STAFF RECOMMENDATION
118 Lauderdale Road
November 16, 2016

Application: New construction—addition; partial demolition
District: Cherokee Park Neighborhood Conservation Zoning Overlay
Council District: 24
Map and Parcel Number: 10312021800
Applicant: Tyler LeMarinel, Allard Ward Architects
Project Lead: Melissa Sajid, melissa.sajid@nashville.gov

Additions and Renovations to:
The Peterson-Lee Residence
118 Lauderdale Road
Nashville, Tennessee 37205

Figure 2: Attached garage to be demolished

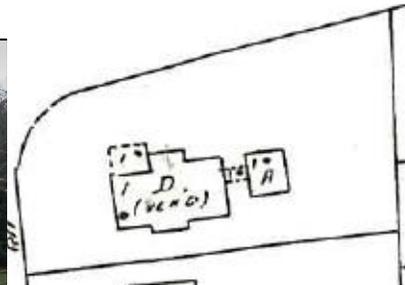
Demolition: The applicant proposes to demolish an existing garage that is attached to the house by a covered connector (Figure 2). The date of construction of the attached garage is not known, but a different garage in a similar location appears on the 1957 Sanborn maps (Figure 3). Staff finds that it is not a significant feature of the house given its location and method of connection and that removal will not significantly impact the character of the house or the Cherokee Park neighborhood. Staff therefore finds that its demolition meets Section III.B.2 for appropriate demolition and does not meet section III.B.1 for inappropriate demolition.

① West Elevation
 Scale: 1/8"=1'-0"

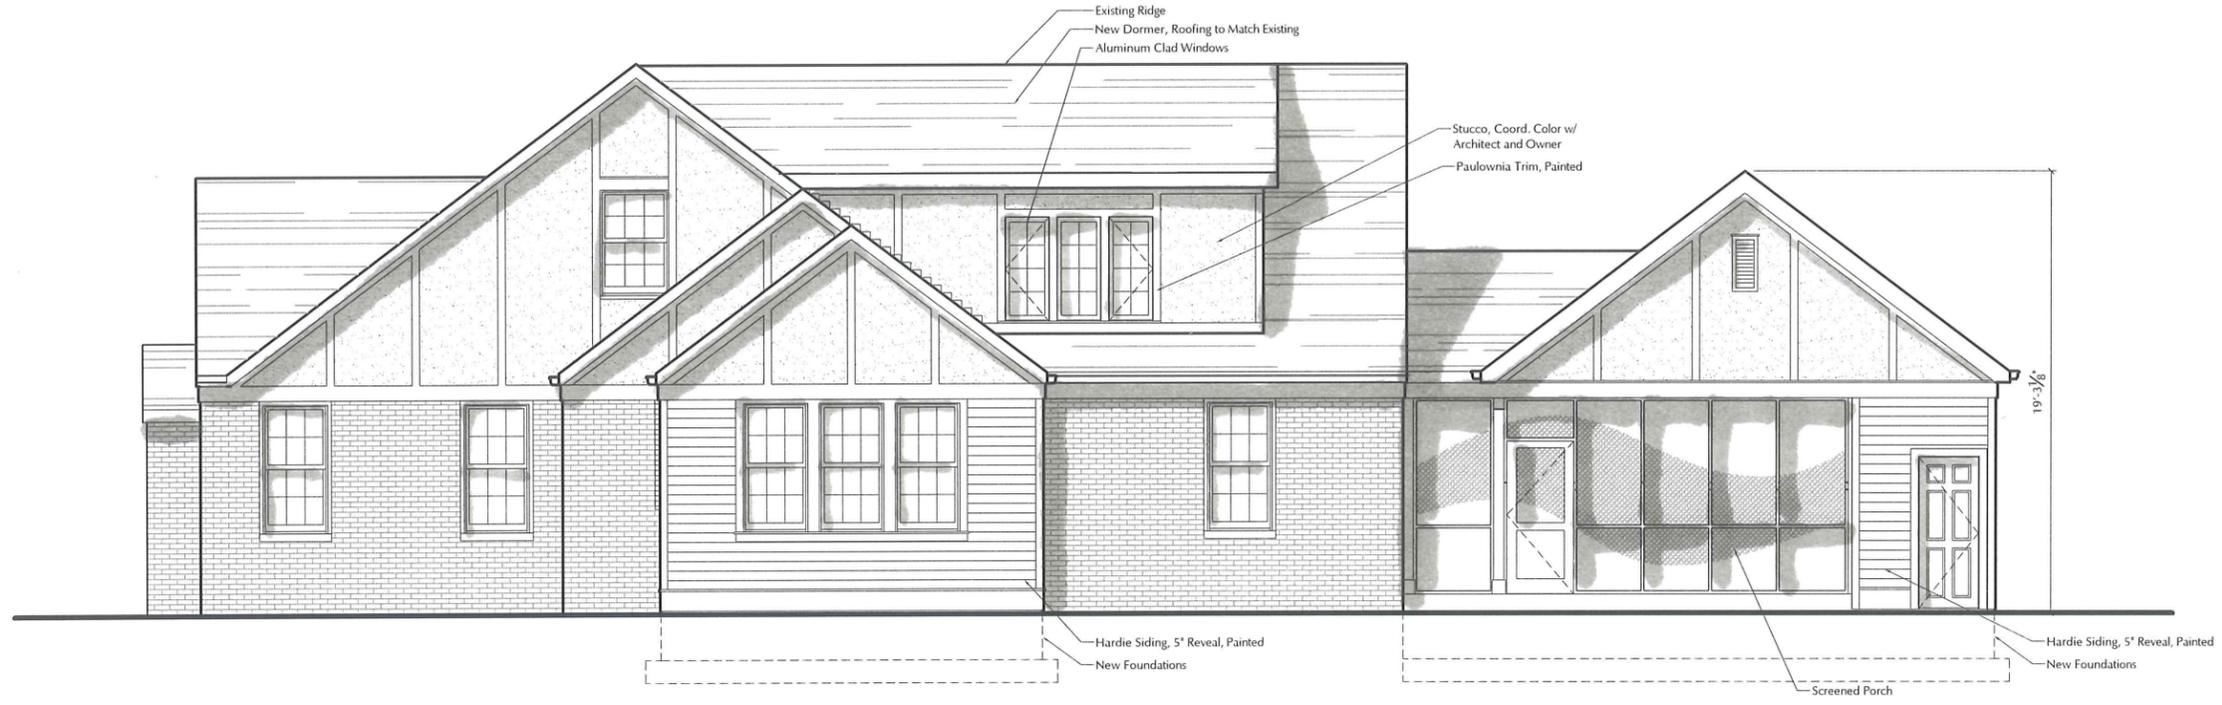
The rear addition also includes side dormers tie into the existing side-facing gables at the ridge on both side façades. Staff recommends that the proposed side dormers do not tie in directly to the side facing gables but rather that the dormers are separated so that if the addition were to be removed in the future, the historic character of the house would still be intact.

Roof form: The roof form of the addition is cross gabled, with pitches that complement the existing historic house. The proposed side dormers tie into the existing side-facing gables at the ridge. Staff recommends that the side dormers do not tie in directly to the side facing gables but rather that the dormers are separated so that if the addition were to be removed in the future, the historic character of the house would still be intact. With the

1. The side dormers shall not tie directly into the existing side gables on the historic house;
2. The left side setback shall be a minimum of seventeen feet, nine inches (17'-9") with a new site plan showing this condition;
3. Staff approve the final details, dimensions and materials of roof material, roof color, windows, pedestrian doors, and vehicular doors prior to purchase and installation; and,
4. The HVAC shall be located behind the house or on either side, beyond the midpoint of the house.
